Service Kit

759-04142

Subject: Service Replacement for the 42" RZT Left Hand (LH) Hydro Transmission

PURPOSE: This service kit replaces the LH hydro transmissions 618-04164A and 618-04327 which are no longer available. The replacement transmission has a Double-D axle end which requires a Double-D wheel hub assembly. A new neutral return spring is enclosed for the RH transmission. See instructions on page 2 of this sheet.

FIGURE 2

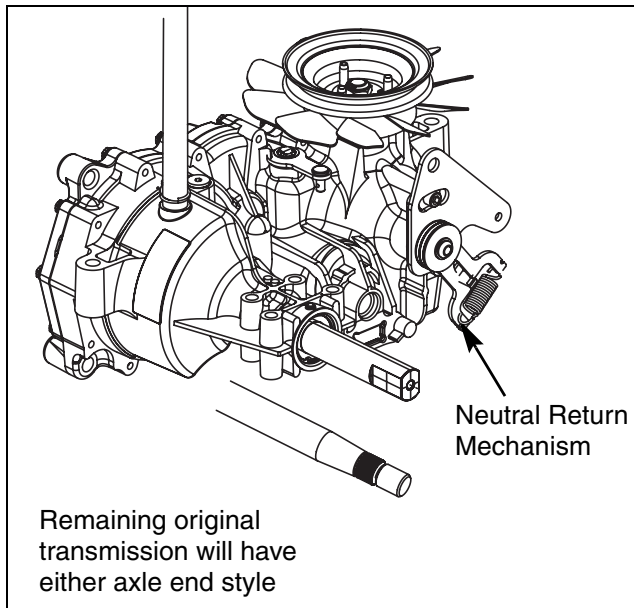
1. A Neutral Return Extension Spring, Item 7, is supplied with this kit for installation on the remaining hydrostatic transmission when only one hydrostatic transmission is being replaced.
2. This spring, Item 7, must be installed on the remaining hydrostatic transmission in order for both transmissions to come to neutral at the same rate.
3. See Figure 2 for location of the neutral return mechanism.

FIGURE 3

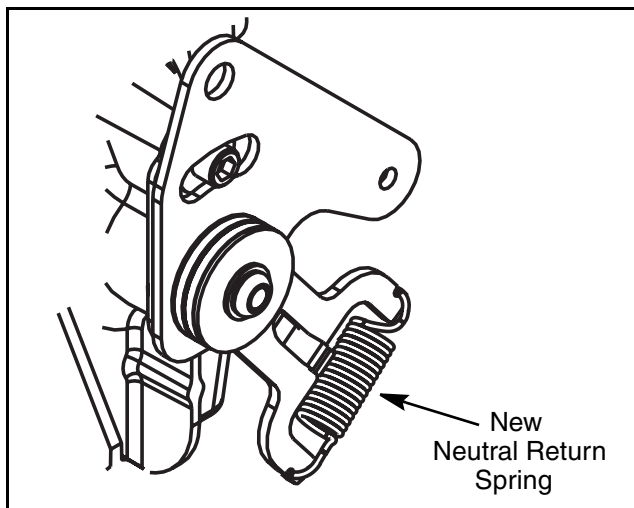
4. With a suitable set of pliers or spring removal tool, remove and discard the existing spring from the neutral return mechanisms two arms on the remaining (not replaced with this kit) hydrostatic transmission. See Figure 3.

5. Install the new Neutral Return Spring, Item 7, onto the two as shown in Figure 3.
6. When complete both installed transmissions must have the same color neutral return spring.
7. This completes the installation of the new Neutral Return Spring onto the remaining original transmission.
